**PLANNING COMMISSION STAFF REPORT
CONDITIONAL USE PERMIT USE2024 0007
HEARING DATE: MAY 14, 2024**

PROPOSAL: Expansion of Community Center from 7,625 to 9,984 square feet. Parking shared with neighboring buildings.

STAFF RECOMMENDATION: Approval with conditions.

SHEET NO.
E111

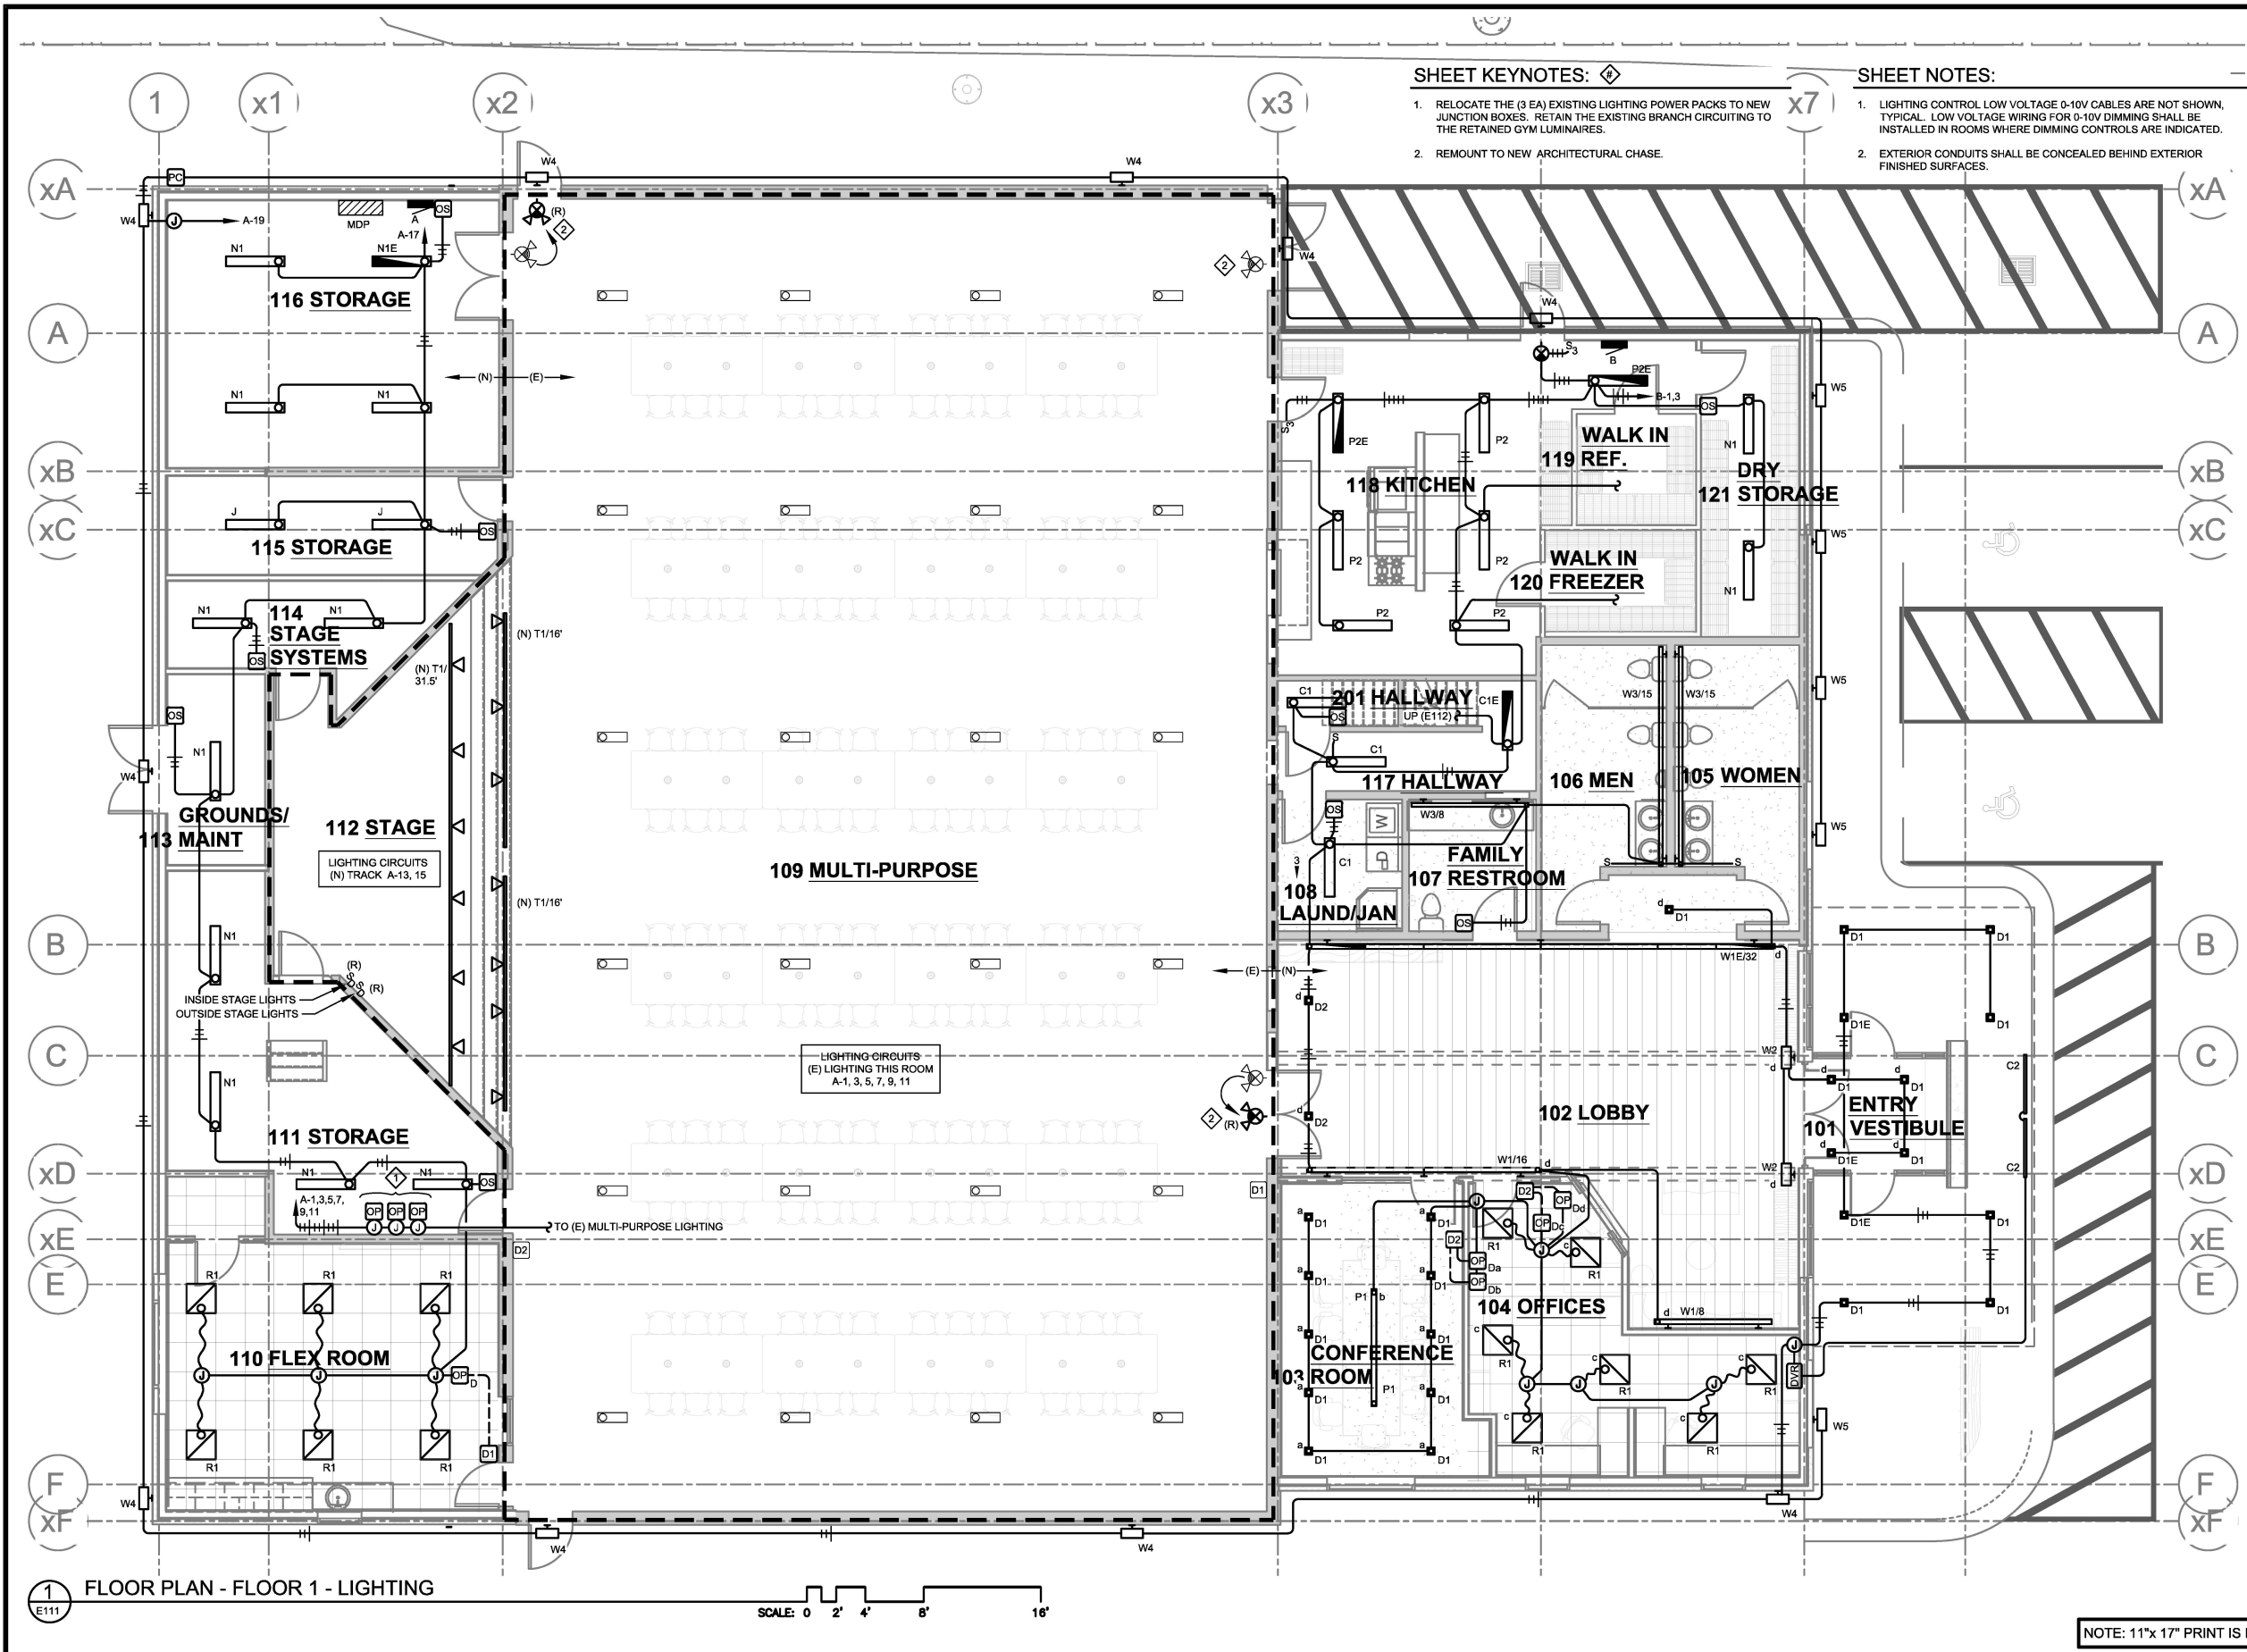
Lighting - The Applicant has provided cut sheets that show shielded, downward cast exterior lighting. A lighting plan is shown in **Attachment A, Sheet E111**.
